COMMUNITY DEVELOPMENT DEPARTMENT REPORT

HEARING DATE: 7/15/2025
Continued from: 7/8/2025

SUBJECT: H-2024-0070
Dayspring Subdivision – AZ, PP

LOCATION: South side of W. Ustick Rd., 1/4 mile east of N. McDermott Rd., in the north 1/2 of Section 4., T.3N. R. 1W. (Parcels: S1204212920, S1204212910, S1204212500, S1204244300, S1204315300, S1204131700)

E. Common Driveway Exhibit – REVISED

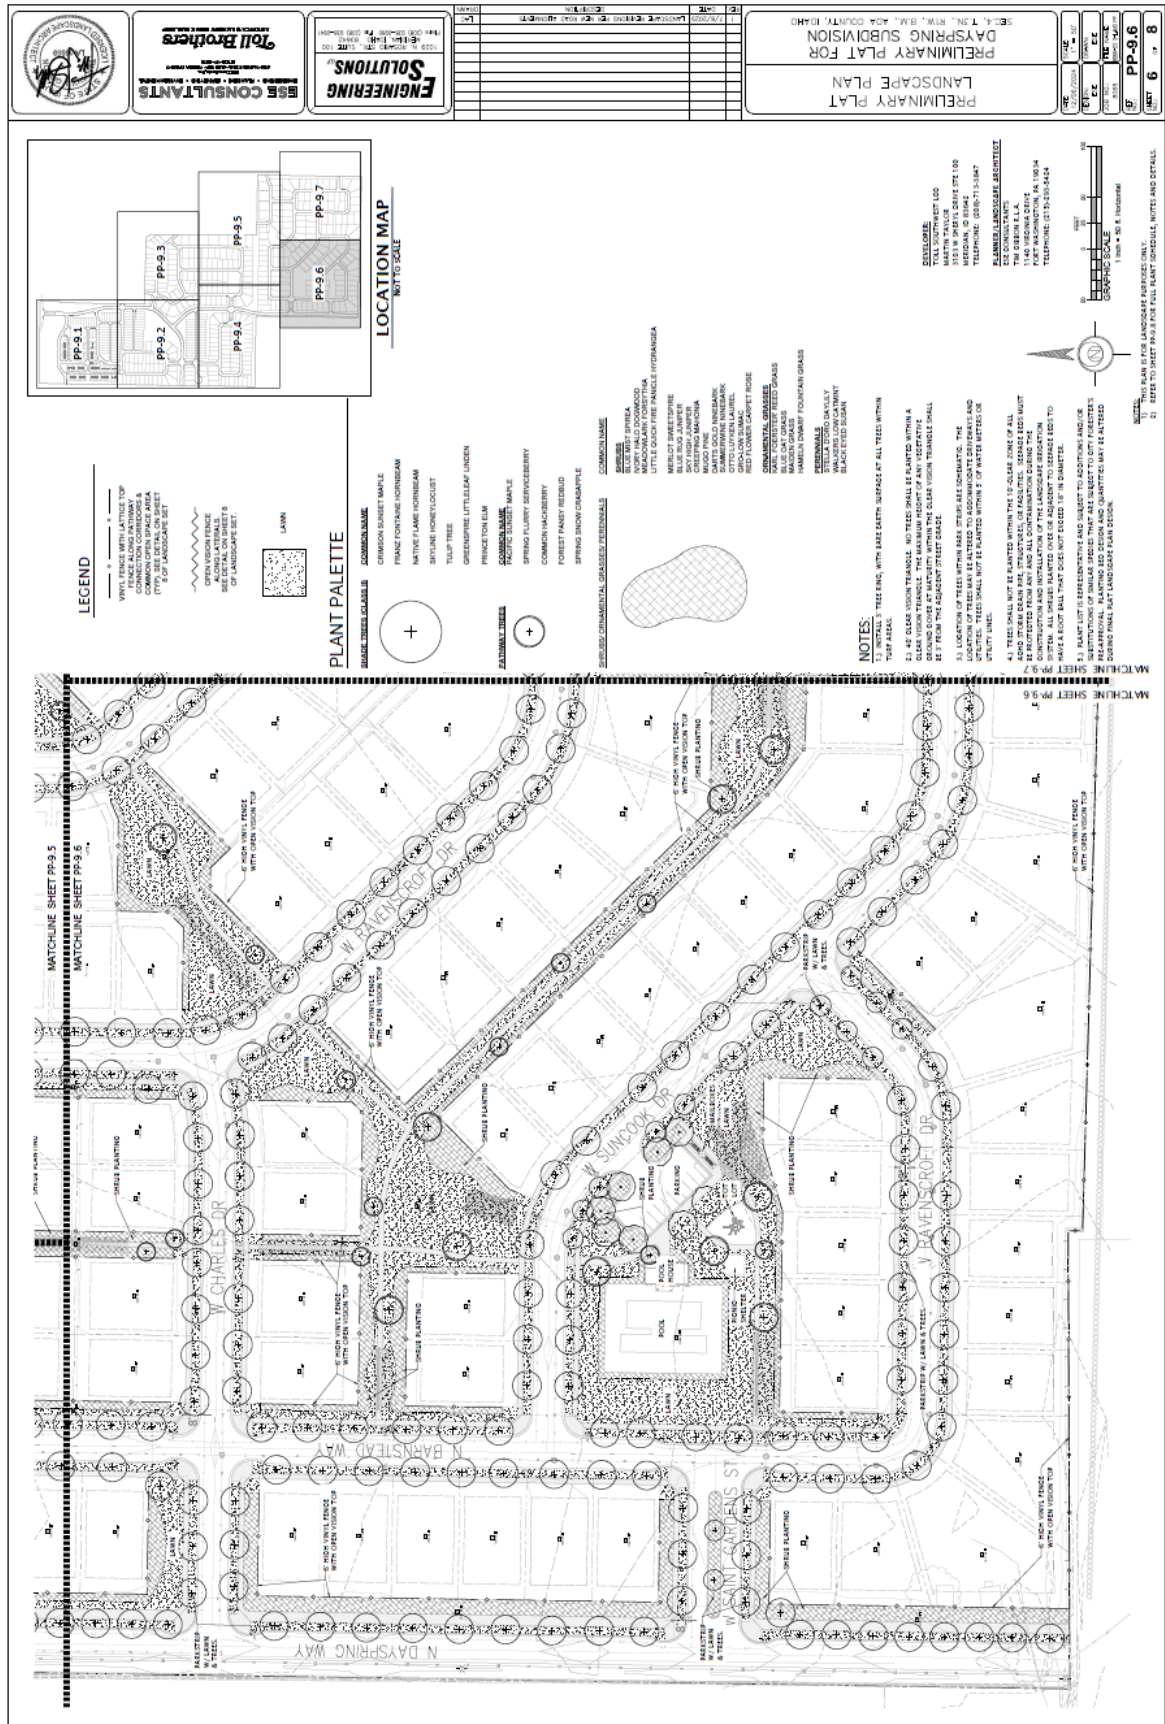
Six (6) common driveways are proposed; see exhibit in Section VII.E below. **All common driveways are required to comply with the standards in UDC 11-6C-3D, which require driveways to be a minimum 20’ in width. The common lots for the driveways also need to extend all the way to the back lot. If solid fencing is proposed adjacent to common driveways, a minimum 5-foot wide landscape buffer planted with shrubs, lawn or other vegetative groundcover should be provided between the driveway and fence. The common driveway exhibits, preliminary plat and landscape plan should be revised to comply with these standards with submittal of the final plat application.**

8. All common driveways shall comply with the standards listed in UDC 11-6C-3D. *A revised common driveway exhibit(s) shall be submitted ~~prior to the City Council hearing~~ with the final plat application that incorporates the changes noted in Section III above.*
